6-1 – 12

602.1, 602.2 (New), 602.2.1, 602.2.2, 602.2.2.3, 602.3, 602.3.1 (New), 602.3.2 (New), 602.3.3 (New), 602.3.4 (New), 602.4, 602.5, 602.6,

Proponent: Kim Paarlberg, International Code Council

604.4, Figure 604.4

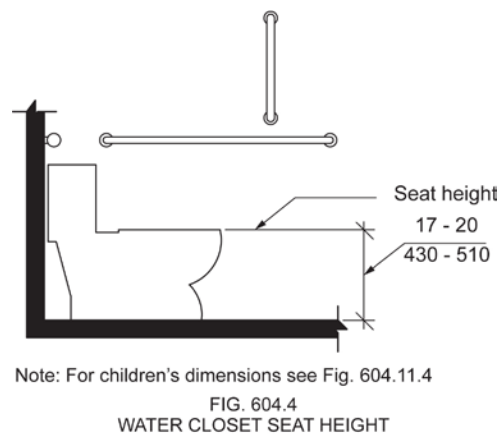
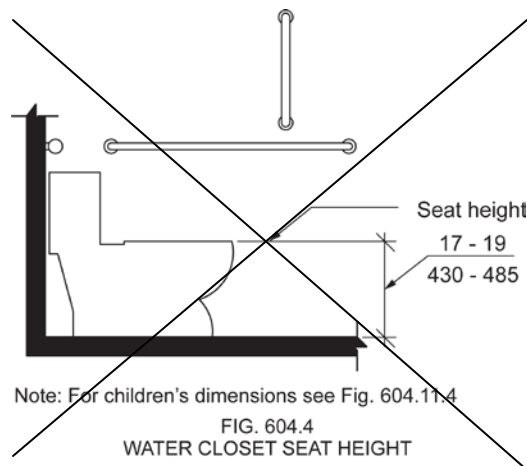
NOTE: This change necessitates a change to Fig. 604.4 to ensure consistency. Thus, the proposed revised figure has been attached, along with the existing figure for comparison purposes.

1. An accessible water closet which is adjustable in height or which provides multiple hinged seats is permitted to provide adjustability within a range of 11 inches (280 mm) minimum to 25 inches (635 mm) maximum, provided that at least one adjustment setting provides a seat within the range specified in Section 604.4.
2. A water closet in a toilet room for a single occupant, accessed only through a private office and not for common use or public use, shall not be required to comply with Section 604.4.

604.5.1, Figure 604.5.1

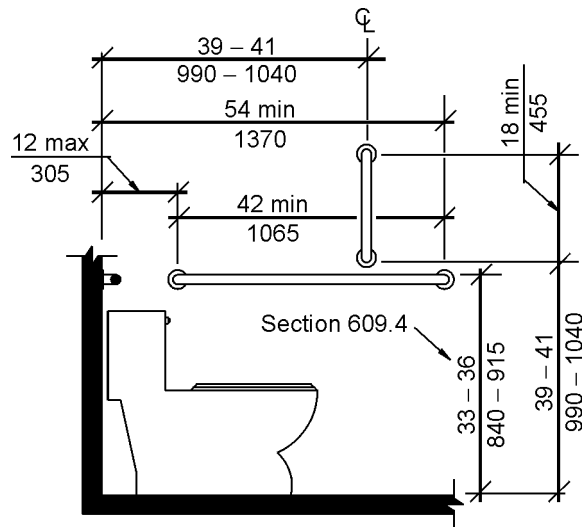
Change dimension call out dimension showing the location of the vertical grab bar in relationship to the rear wall as follows: ~~39 – 41 (990 – 1040)~~ to 39-46 (990 1170)

604.5.1 Fixed Side Wall Grab Bars. Fixed side-wall grab bars shall be 42 inches (1065 mm) minimum in length, located 12 inches (305 mm) maximum from the rear wall and extending 54 inches (1370 mm) minimum from the rear wall. In addition, a vertical grab bar 18 inches (455 mm) minimum in length shall be mounted with the bottom of the bar located 39 inches (990 mm) minimum and 41 inches (1040 mm) maximum above the floor, and with the center line of the bar located 39 inches (990 mm) minimum and 41 inches (1040 mm) maximum from the rear wall.

604.7, Figure 604.7

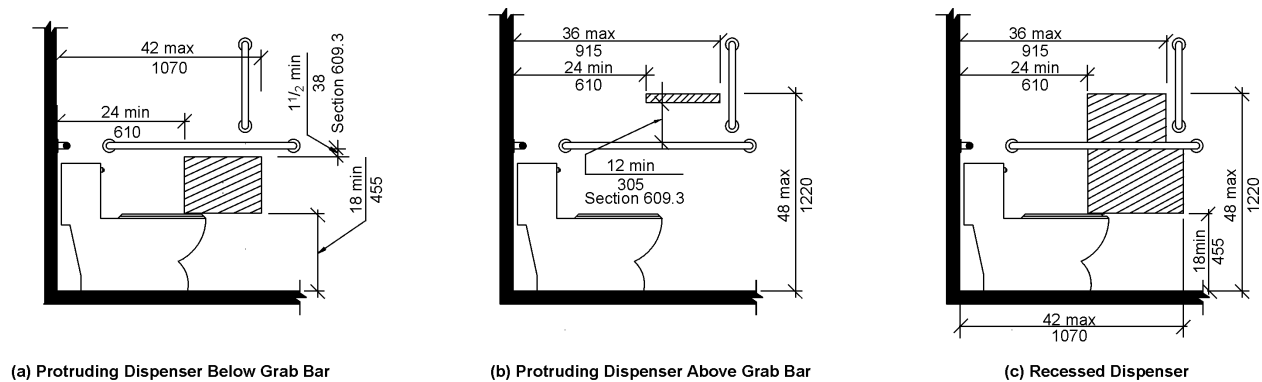
Change the vertical dimension on figures (a) and (c) indicating the vertical placement of dispensers above the floor from : ~~48 min (1220)~~ to 15 min (380).

- Inconsistent with ICC A117.1- 2009 Section 3098.2 Forward Reach, 308.2.1 Unobstructed (Page 11), " low forward reach shall be 15 inches (380 mm) minimum"
Figure 308.2.1 Unobstructed Forward Reach (Page 11), dimension call out "15 min (380 mm)"
Section 308.3 Side Reach, 308.3.1 Unobstructed (Page 13, " low side reach shall be 15 min (380 mm)"

- Inconsistent with 2010 ADA Standards Section 604.7 Dispensers (page 201), "the outlet of the dispenser shall be 15 inches (380 mm) minimum"
Figure 604.7 Dispenser Outlet Location (page 202), dimension call out "15 min (380 mm)"

- The change to a common dimension of 15 inches, in effect, may increase accessibility and encourage greater compliance.
- It isn't clear that anthropometric or ergonomic data support an 18" dimension in this location.

Table 604.9.3.1, Figure 604.9.3.1

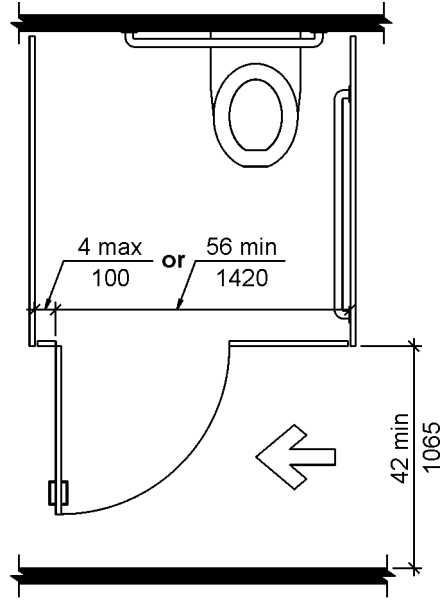
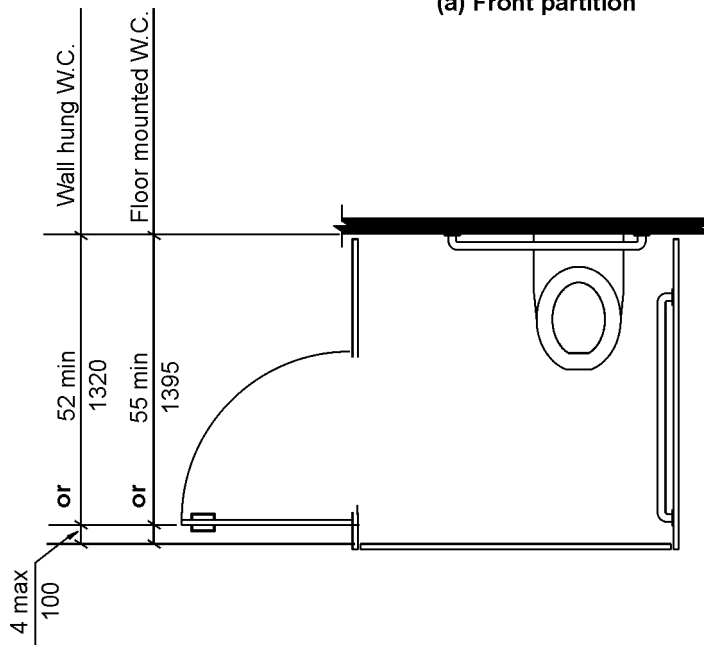
Change the called dimension for door opening location to read: 4 inches (100 mm) minimum to 6 inches (150mm) maximum.

Door Opening Location	Measured From	Dimension
Front Wall or Partition	From the side wall or partition closest to the water closet	56 inches (1420 mm) minimum
	or	
	From the side wall or partition farthest from the water closet	4 inches (102 mm) maximum <u>4 inches 100 mm) minimum</u> <u>to 6 inches maximum (150 mm)</u>
Side Wall or Partition - Wall-Hung Water Closet	From the rear wall	52 inches (1320 mm) minimum
	or	
	From the front wall or partition	4 inches (102 mm) maximum <u>4 inches 100 mm) minimum</u> <u>to 6 inches maximum (150 mm)</u>
Side Wall or Partition - Floor-Mounted Water Closet	From the rear wall	55 inches (1395 mm) minimum
	or	
	From the front wall or partition	4 inches (102 mm) maximum <u>4 inches 100 mm) minimum</u> <u>to 6 inches maximum (150 mm)</u>

Figures 604.9.3.1 (a), (b), (c), Figure 604.9.5 (c)

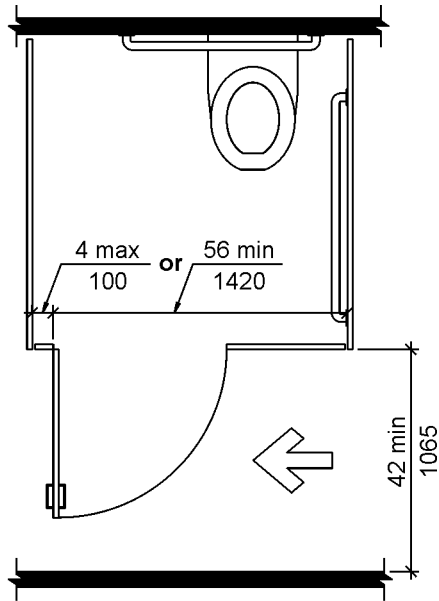
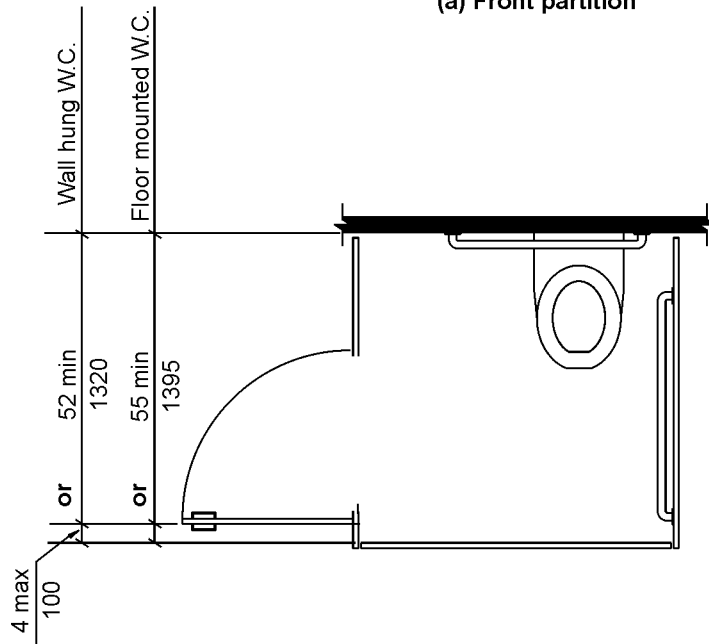
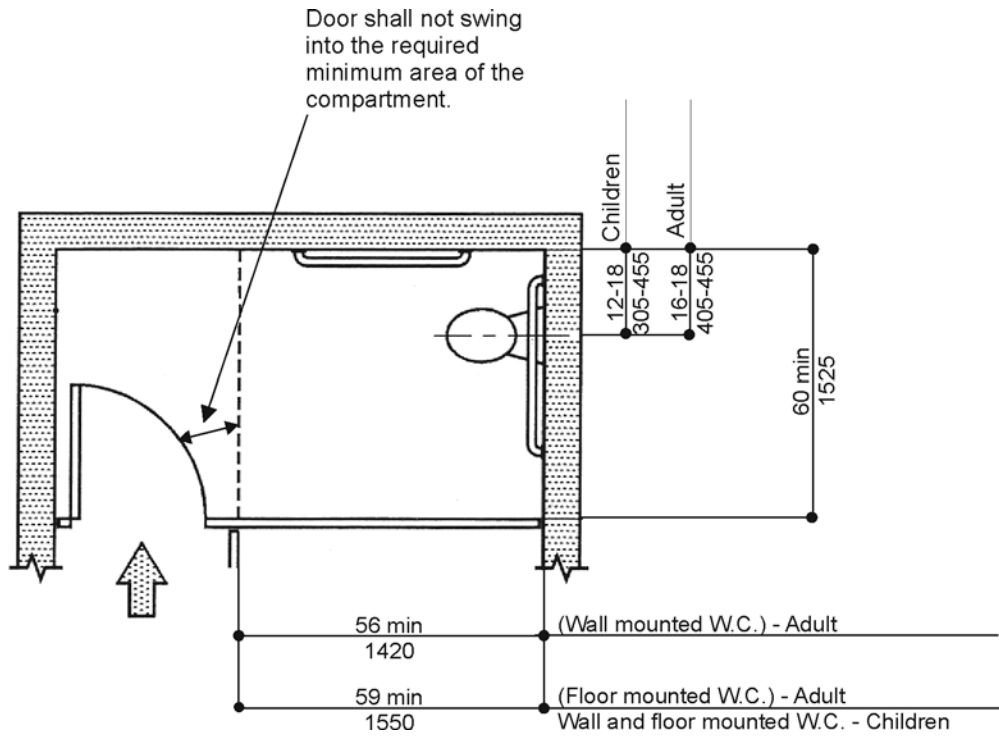
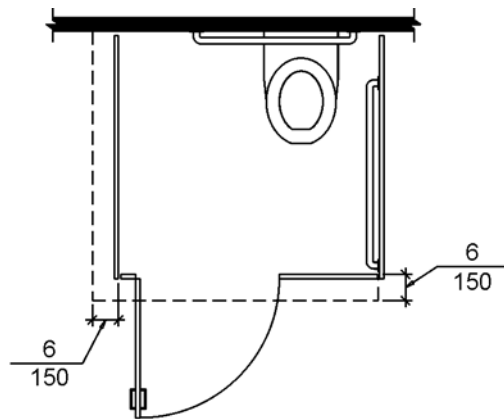
Revise each figure to indicate the placement of the vertical grab bar required for each.

Reason: Figures 604.9.3.1(a), (b), (c) and 604.9.5 (c) do not reflect a vertical grab bar. Though these figures clearly address wheelchair accessible compartment door openings, they should be consistent with other illustrations which address other elements within the compartment yet reflect the vertical grab bar. To maintain consistency among Figures, the vertical grab bar should be reflected in these illustrations. The vertical grab bars are reflected in other figures – for example: Figures 604.9.2 (a), (b) address wall hung and floor mounted water closets yet they reflect a vertical grab bar in the illustrations. Example: Figures 604.9.2 (a), (b) specifically address wall hung and floor mounted water closets yet they reflect a vertical grab bar in the illustrations.

604.9.5, Figure 604.9.5, 609.5.1, 609.5.2

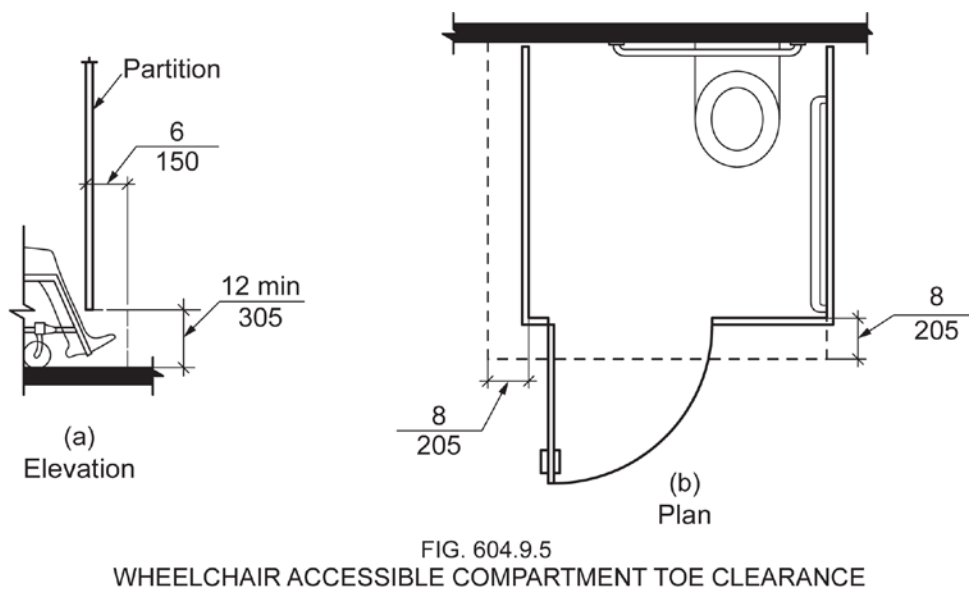
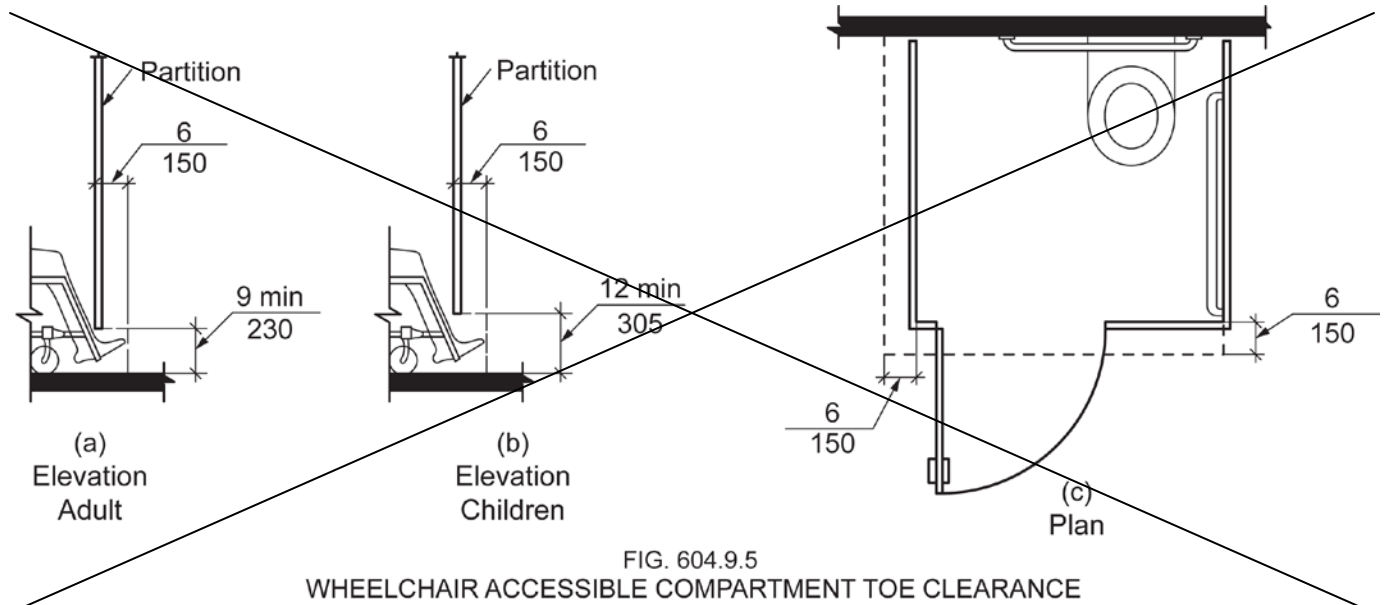
These figures assume the wheelchair occupant is as far forward to the partition as possible but it does not account for the total occupied length of the device. Based on the existing ANSI standard, we propose that the exceptions be changed accordingly to account for the additional 2 inches of space added for toe clearance. This means that if an adjacent compartment does not have the requisite 8 inches, the accessible compartment must have 2 more inches than previously required in order to be exempted. Further, Steinfeld, et al., 2010 (pg. 95, fig. 4-5) notes that in order to allow 95% of power and manual wheelchair users to perform a 180-degree turn, a 67-inch width is necessary, which is consistent with the proposed change to the exemptions.

There is no research to support changes to the children's figure, thus our proposal of a 12-inch toe clearance height now aligns with the existing children's toe clearance height, therefore we have eliminated the distinction in this proposal.

NOTE: This change necessitates a change to Fig. 604.9.5 to ensure consistency. Thus, the proposed revised figure has been attached, along with the existing figure for comparison purposes.

604.9.5 Toe Clearance at Compartments. ~~Toe clearance for compartments primarily for children's use shall comply with Section 604.9.5.2. Toe clearance for other wheelchair accessible compartments shall comply with Section 604.9.5.1.~~

604.9.5.1 Toe Clearance at Compartments. ~~The front partition and at least one side partition of compartments shall provide a toe clearance of 9 12 inches (230 305 mm) minimum above the floor and extending 6 8 inches (150 205 mm) beyond the compartment side face of the partition, exclusive of partition support members.~~

Fig. 604.10
Ambulatory Accessible Compartment

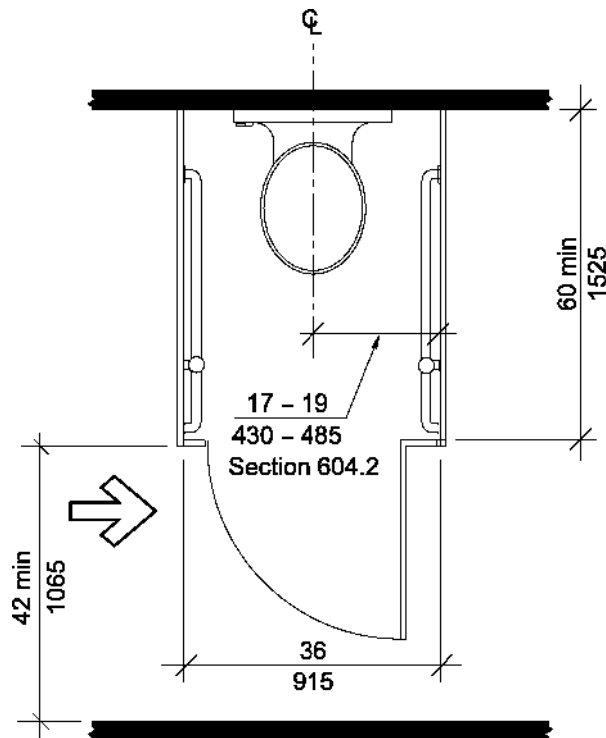
Change the called out dimension for the width of the compartment from ~~36 (915)~~ to 40 inches (1015)

1. A 40" Ambulatory Accessible compartment would allow use of a 3" wide stile on each side of the door opening. The 3" wide stile would provide room for attachment of door hinges and latch keepers. The 3" wide stiles would provide more structural support and rigidity for the side panels and the door hinging and closing than a 1" wide stile or wall post. The 3" wide stile conforms to toilet partition industry standard practice. The 1" wide stile or wall post is not standard.

FIG. 604.11.7
 CHILDREN'S DISPENSER OUTLET LOCATION

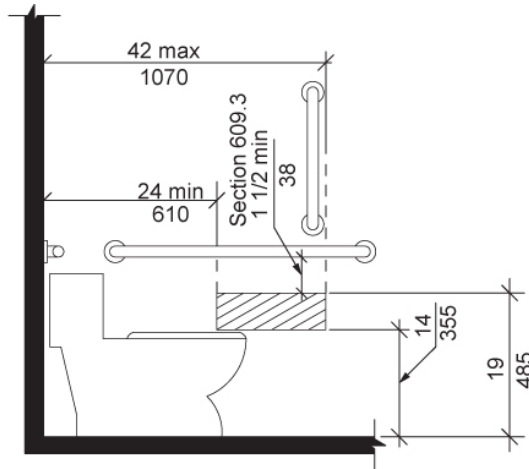
Reason: Section 604.11.7 requires, "The outlet of the dispenser shall be 14 inches (355 mm) minimum and 19 inches (485 mm) maximum above the floor." However, the existing figure does not accurately depict this condition. The figure depicts the bottom location of the dispenser as being within a range of 14-19 inches, but gives no dimension for the top of the dispenser. The figure should be corrected to more accurately reflect the text. It should label 14 inches to the bottom of the shaded area, and 19 inches to the top of the shaded area. The existing drawing was included above for reference purposes.

Fig. 604.12.3
Elder Size of Clearance for Water Closet

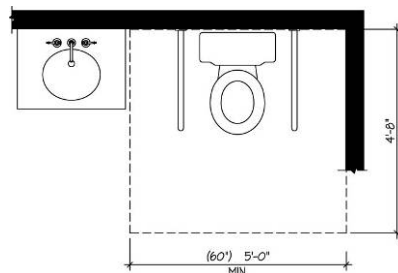
Reason: Increased side wall clearance. Space is needed on both sides of the toilet to accommodate the range of transfer techniques including the front approach normally used in independent sit to stand transfers; caregivers to stand on either or both sides, for one- or two-person assisted transfers as necessary; and for use of a mechanical lifting device.

604.12.3.1 Size A clearance around a water closet 60 inches (1525 mm) minimum, measured perpendicular from the sidewall, and 56 inches (1420 mm) minimum, measured perpendicular from the rear wall, shall be provided.

606.3, Figure 606.3

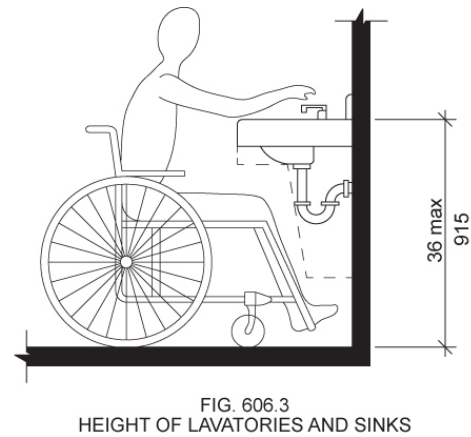
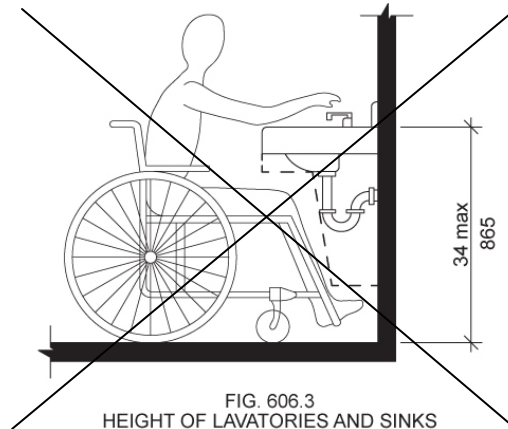
A proposed change to Section 306 would raise the knee clearance height minimum to 29 inches, up from 27 inches, a difference of 2 inches. Changing the maximum rim height by the same 2 inches would allow many existing lavatory products to still comply with the standard by only being mounted 2 inches higher. Steinfeld, et al., 2010 demonstrates that the limiting factor in reaching a target (faucet controls, for example) when using a forward approach is not the height of the obstruction; it is the depth that influences

Further, by raising the maximum height to 36 inches, it would now align with the common industry practice of 36-inch height countertops. It is reasonable to assume such a change would not affect other groups of individuals such as those with short stature because the proposed 36 inches is still lower than the current ANSI requirement of 38 inches maximum height for checkout counters.

NOTE: This change necessitates a change to Fig. 606.3 to ensure consistency. Thus, the proposed revised figure has been attached, along with the existing figure for comparison purposes.

FIG. 607.2(b)
CLEARANCE FOR BATHTUBS

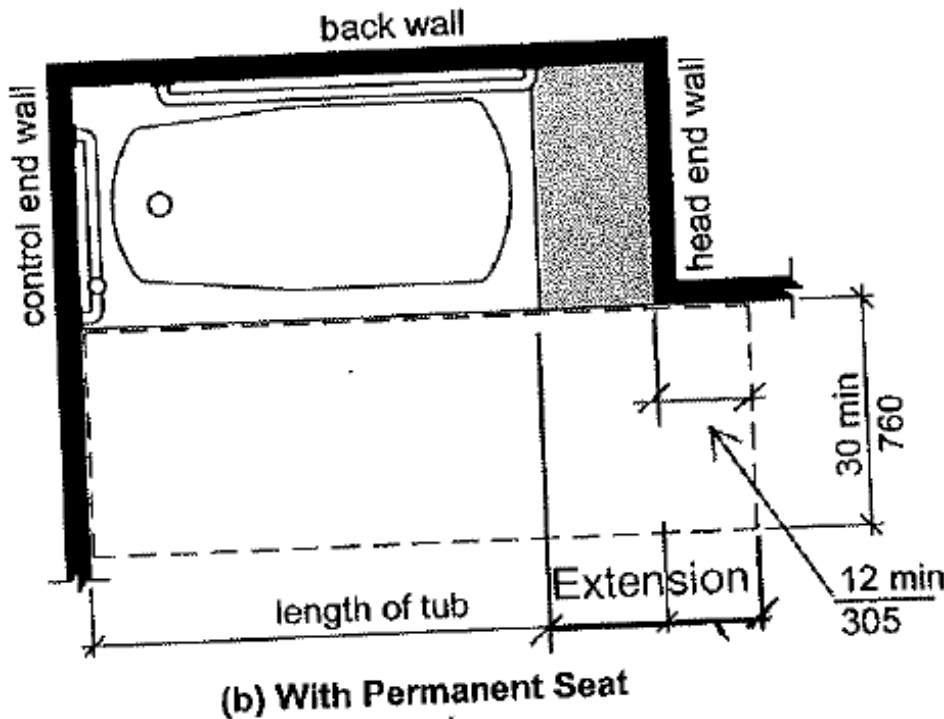
Section 607.4.1 sets the 'depth' of the seat. The current language skips the piece between the 'length of the tub' and the end of the extension. This is a technical issue that just gives you all the pieces. Please see graphic revision attached.

608.4.3, Figure 608.4.3

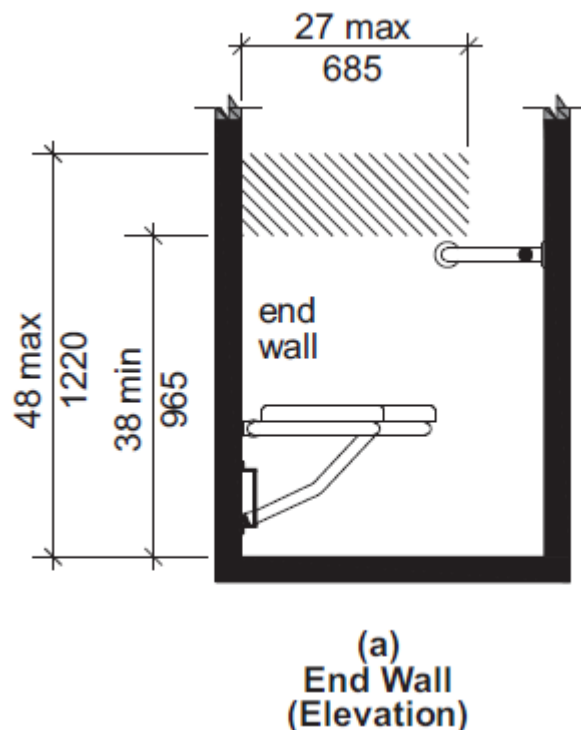
Modify figure to show a 16 inch minimum requirement to go along with the existing 27 inch maximum dimension to create a range for controls to be located and measured from seat wall.

In the 2009 edition of the standard, Section 608.4.2 dealing with a standard roll-in shower was modified to create this 16 to 27 inch range for the controls. The purpose behind that change was to ensure the controls were not located over the seat and did not require a person using the seat to reach beside or behind them to operate the controls. It seems appropriate to make the alternate roll-in shower requirement consistent and also keep the controls forward where they will be more usable.

Fig. 608.4.4
Alternate Roll-In Shower
Compartment for Elder Use
Control and Hand Shower Location

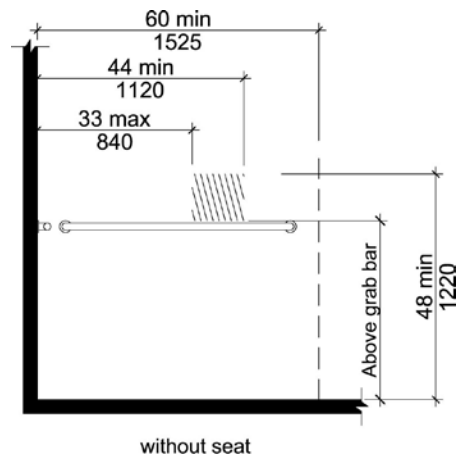
Reason: Provides location for assistance in bathing. See , also White Paper, dated April 22, 2012

608.4.4 Alternate Roll-In Type Shower Compartments for Elder Use. The controls and hand shower provided in a roll-in type shower compartment for elder use shall be located on the back wall above the grab bar, 48 inches (1220 mm) maximum above the shower floor and 16 inches (405 mm) minimum and 44 inches (1120 mm) maximum 33 inches (840 mm) from the side wall.
